E8363B-01C

S E R V I C E N O T E

E8363B PNA Series RF Network Analyzers

Serial Numbers: 00000000 thru 46999999

Figure 1

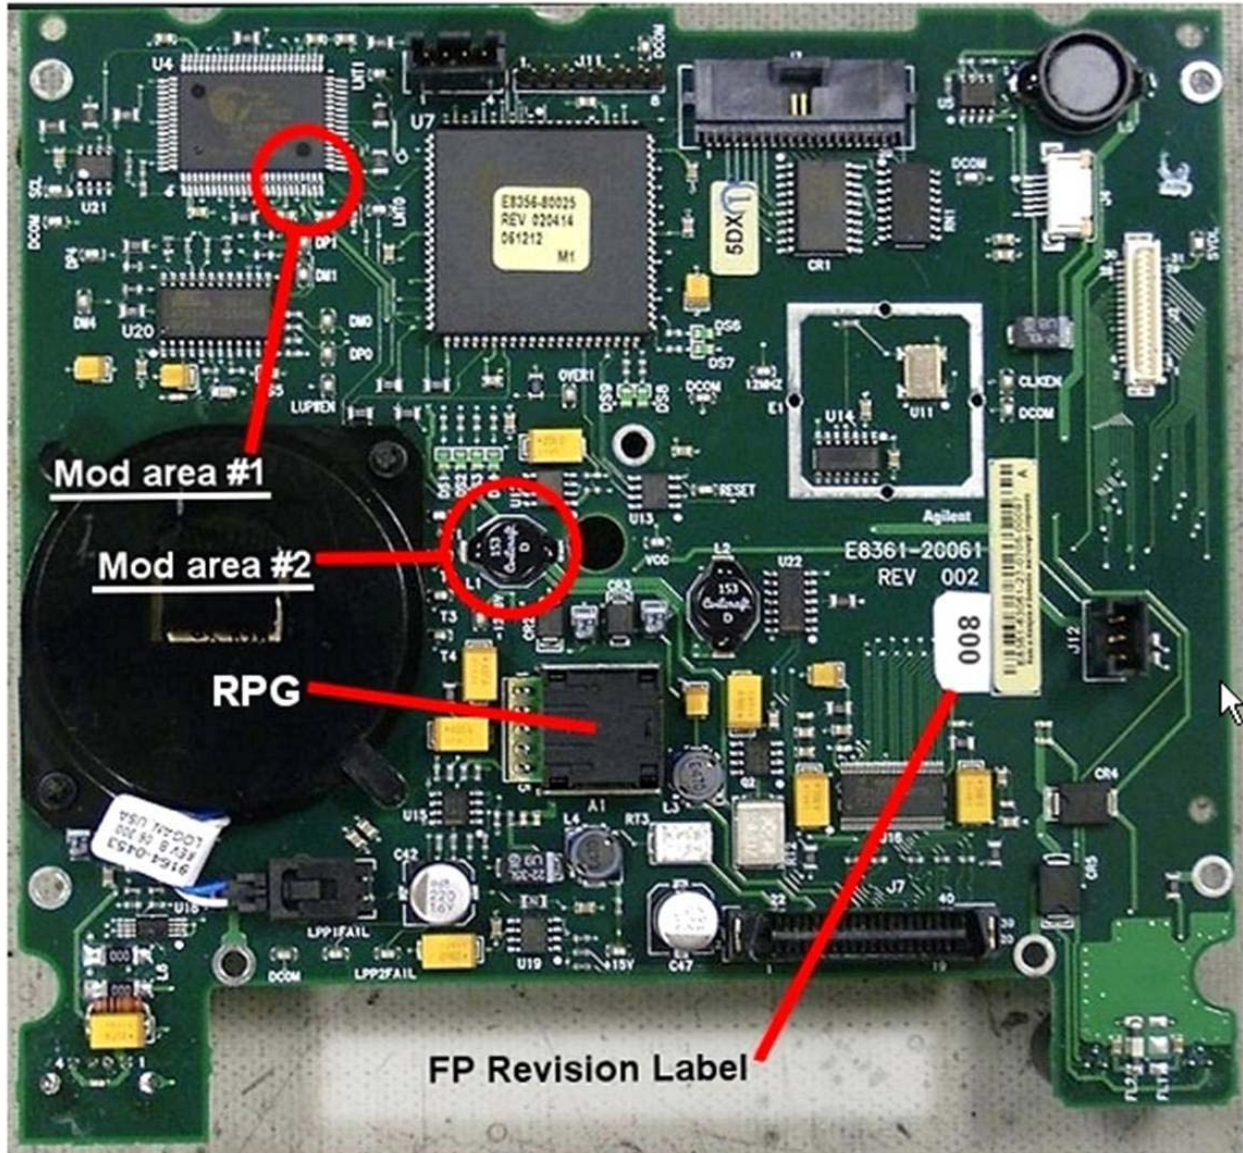
Refer to Figure 1 for the two modification areas to be addressed. Note that while this picture happens to show the FPI board completely removed from the front frame assembly, this is not necessary to perform the required modifications.

- Modification #1 consists of shorting two pins of U4 together with a small amount of solder.
- Modification #2 consist of removing L1.

Figure 2

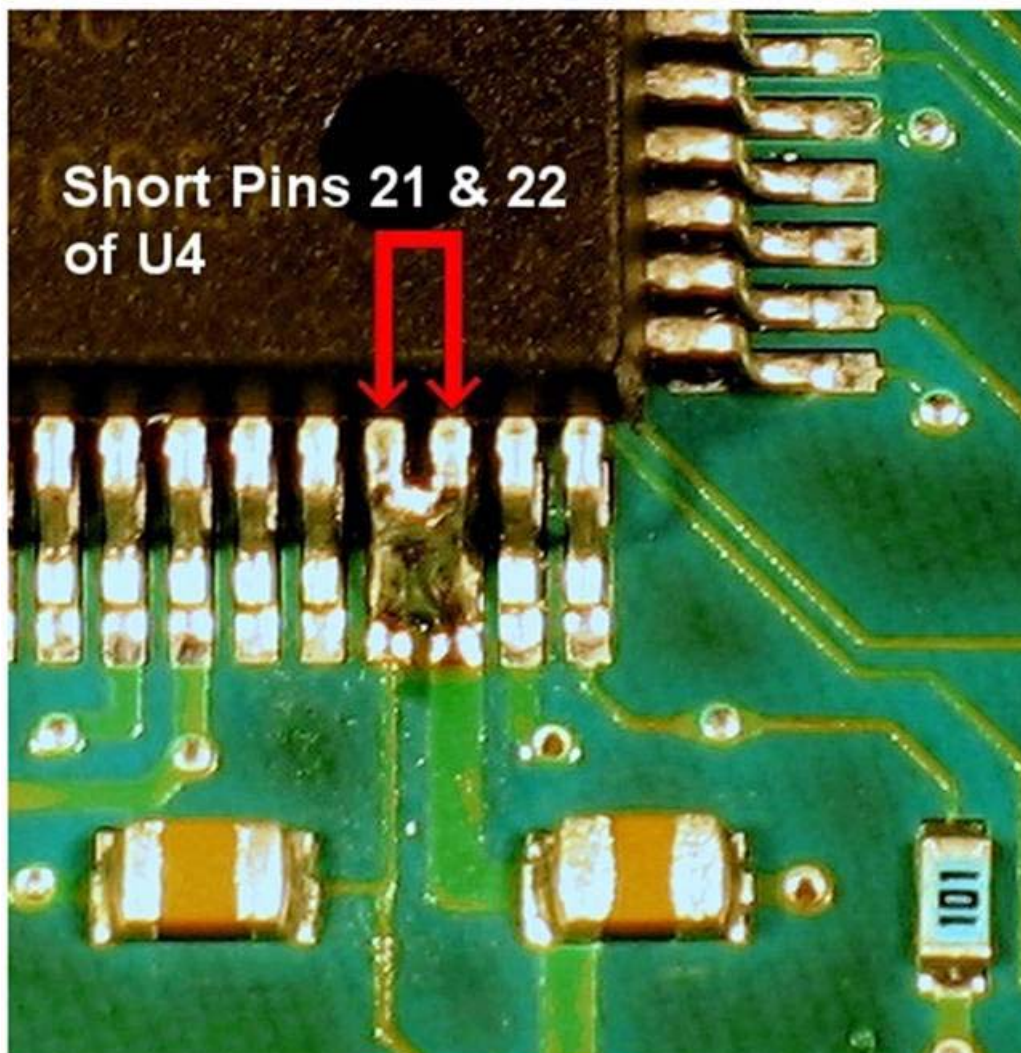
Carefully solder pins 21 and 22 together on U4. Refer to Figure 2 for the exact location. Use care so that no other pins are shorted. Use of a very fine tip soldering iron is recommended and a large work-task magnifying glass is very helpful.

Unsolder and completely remove the black surface mount inductor L1 from the front panel assembly board. This is no longer needed and can be discarded.
